# DCR PHOENIX HOMES

LOT #13  
 DIAMONDVIEW ESTATES - PHASE 2  
 NEWINGTON  
 OPTIONAL CHEF'S KITCHEN  
 (GARAGE LEFT)

### KITCHEN - 3D VIEW #1

DCR #13 Diamondview 2 - Newington Chef's

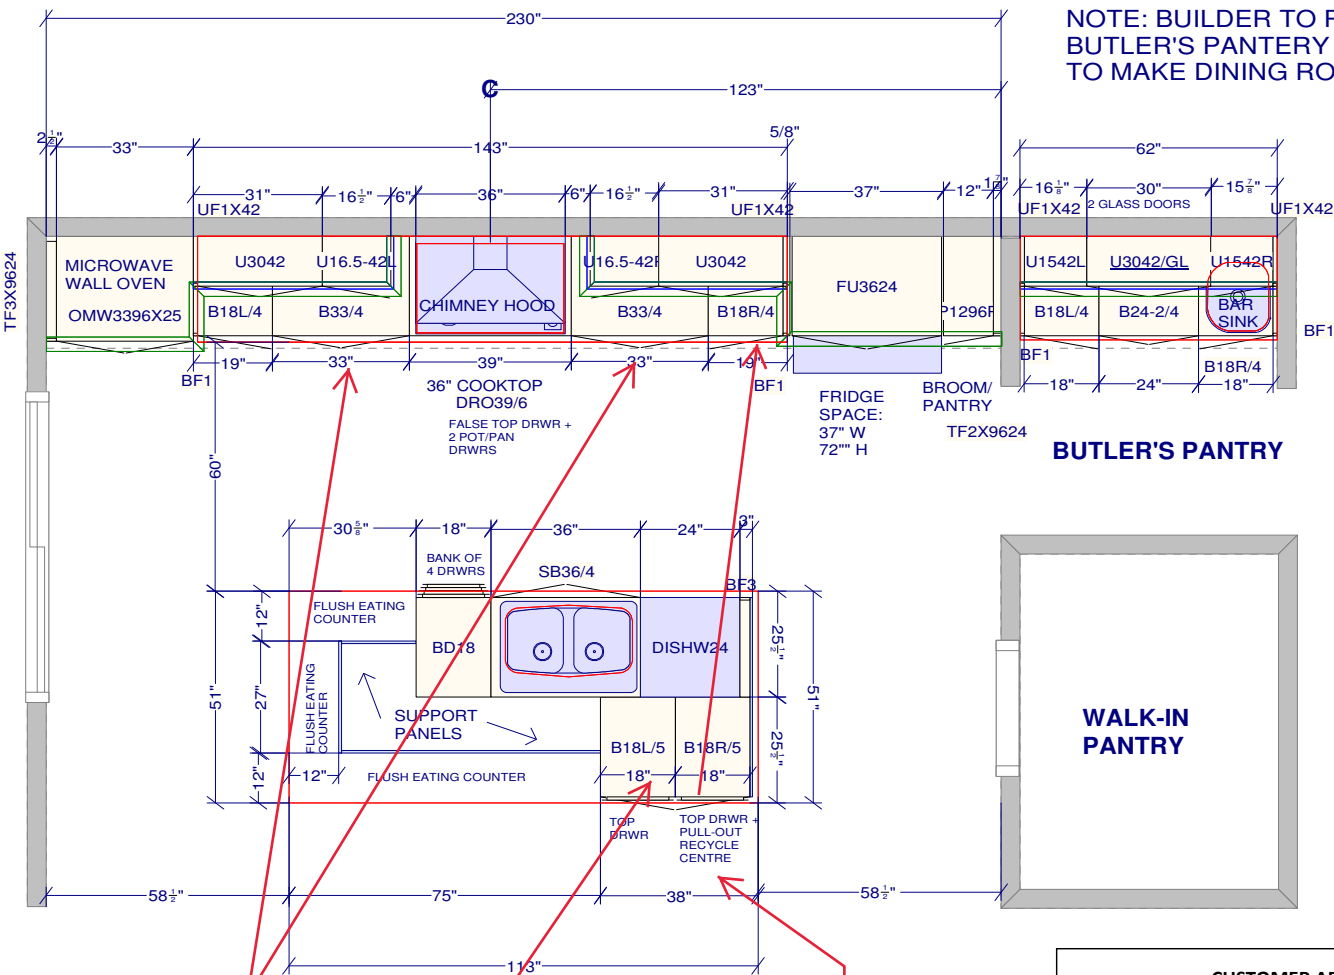
NOTE: BUILDER TO REDUCE BUTLER'S PANTRY TO MAKE DINING ROOM LARGER

Replace these the two 18" cabinets with a single 36" cabinet with 2 full height doors - top drawers to be relocated to either side of the stove

Relocate recycling centre to the left of the fridge

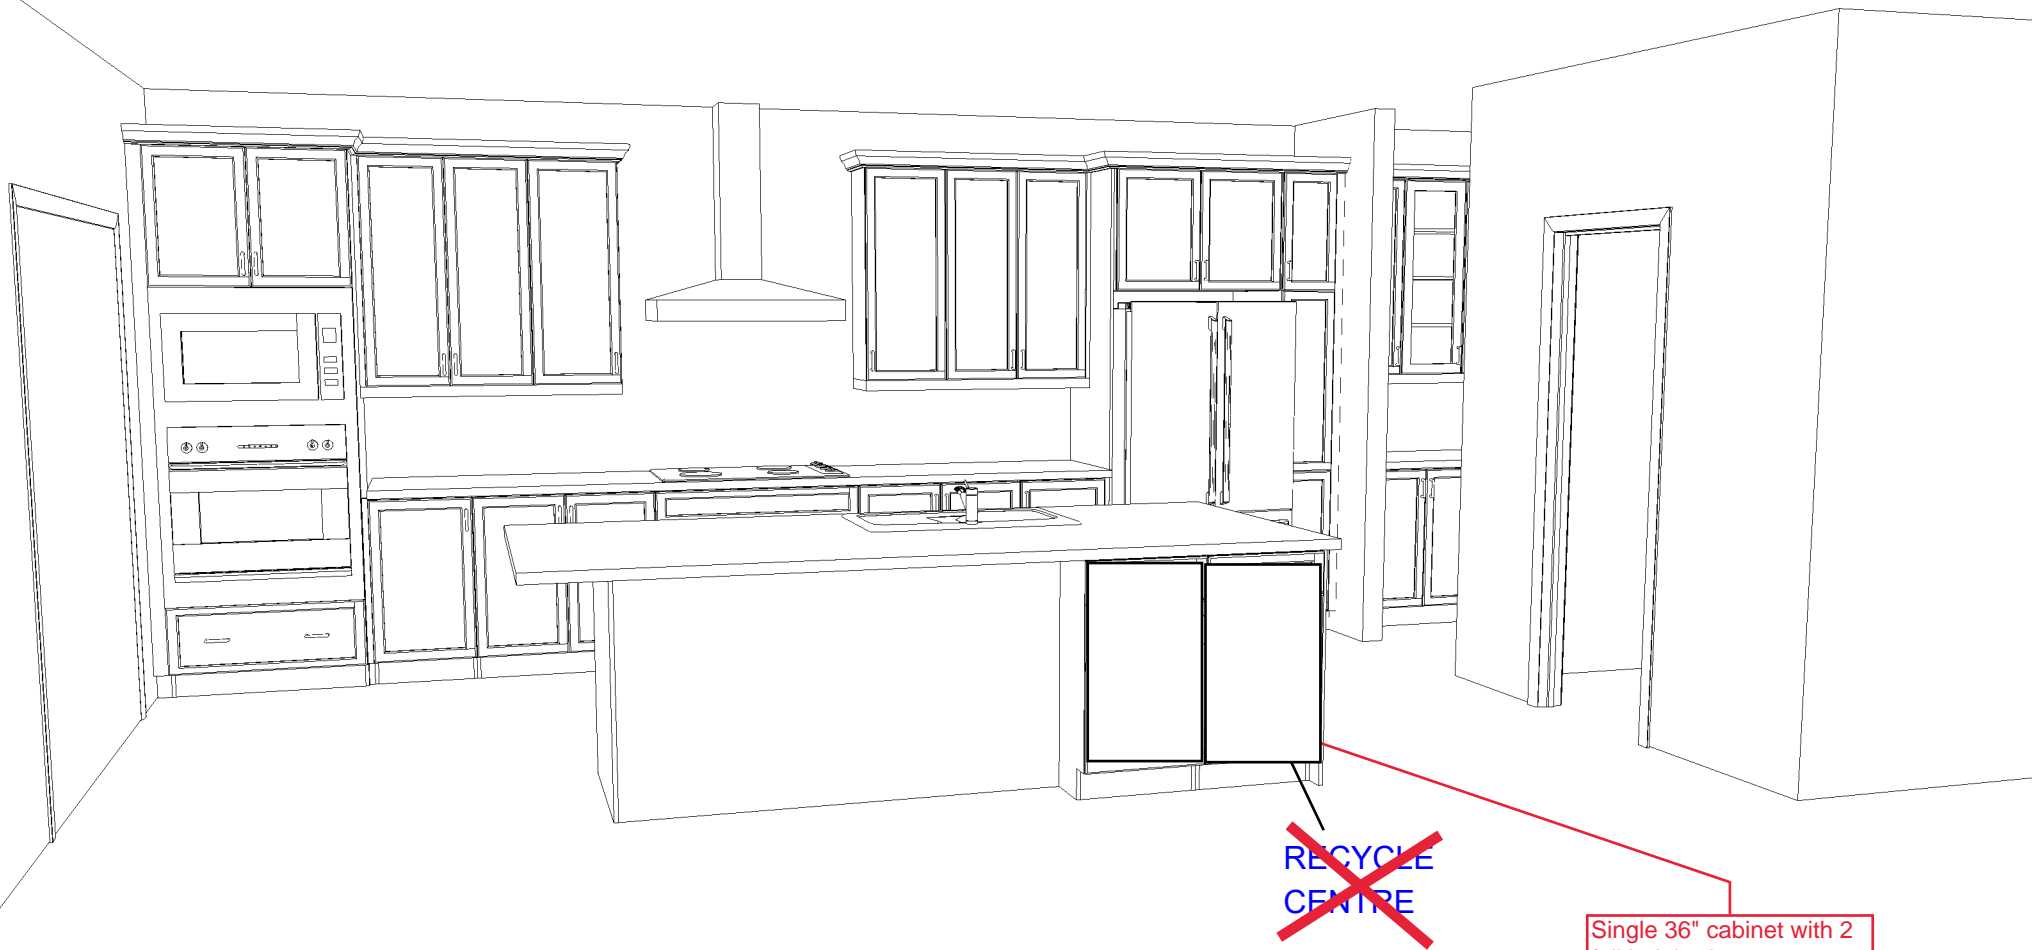
RECYCLE  
CENTRE

Single 36" cabinet with 2  
full height doors

OVEN / COOKTOP/ FRIDGE WALL ELEVATION

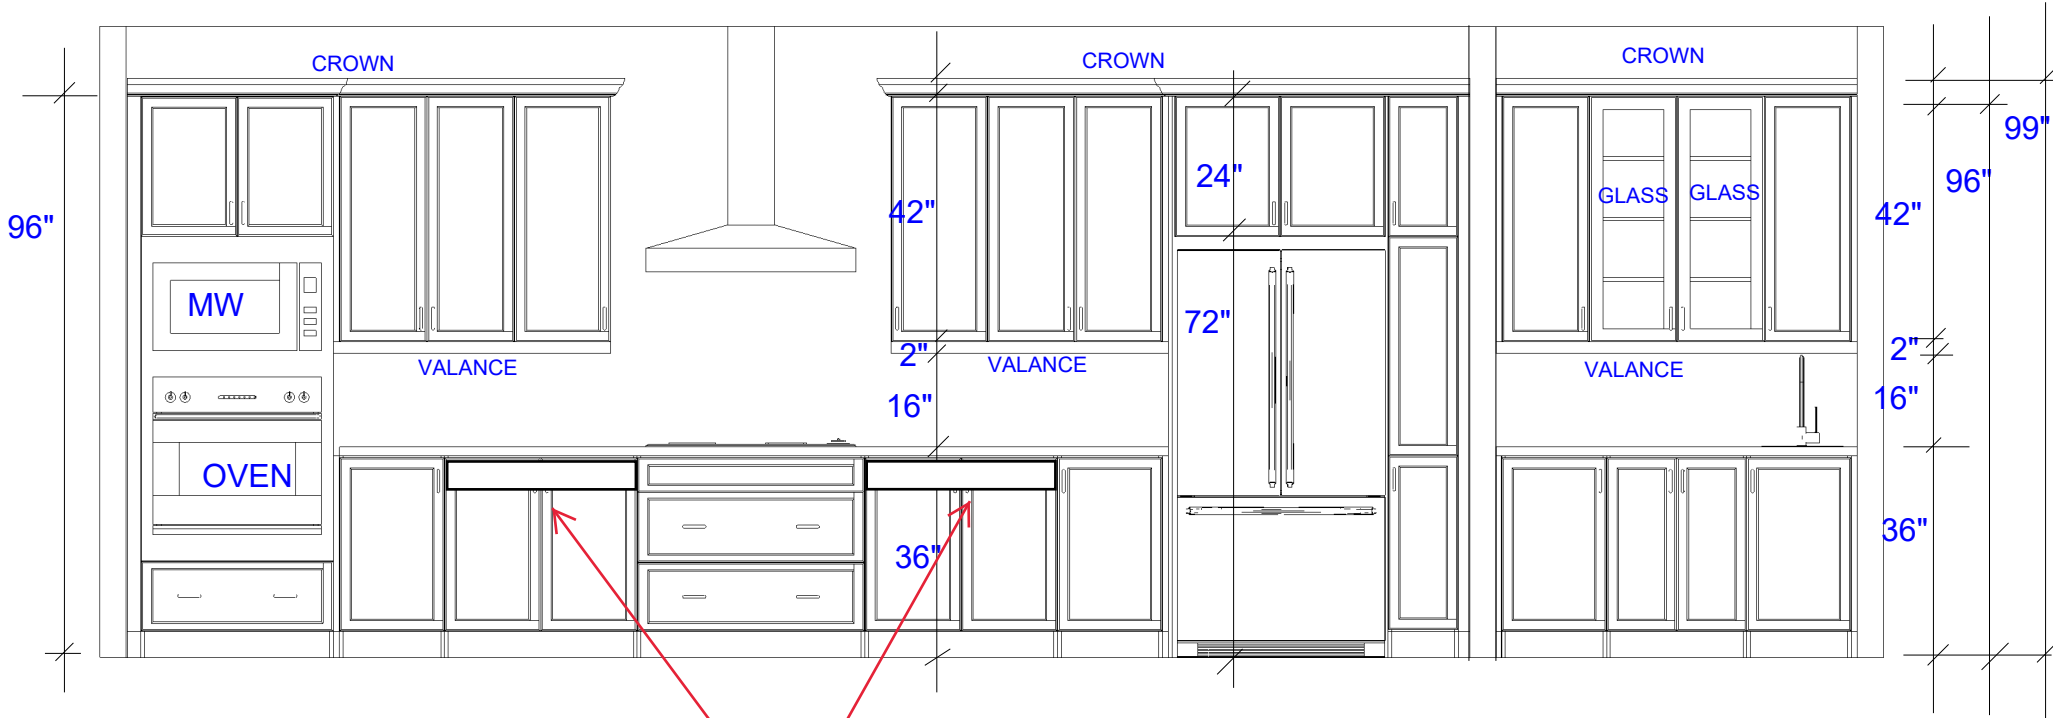
BUTLER'S PANTRY

Relocate drawers from back side of island to either side of the cooktop. Drawers to be single top drawers.
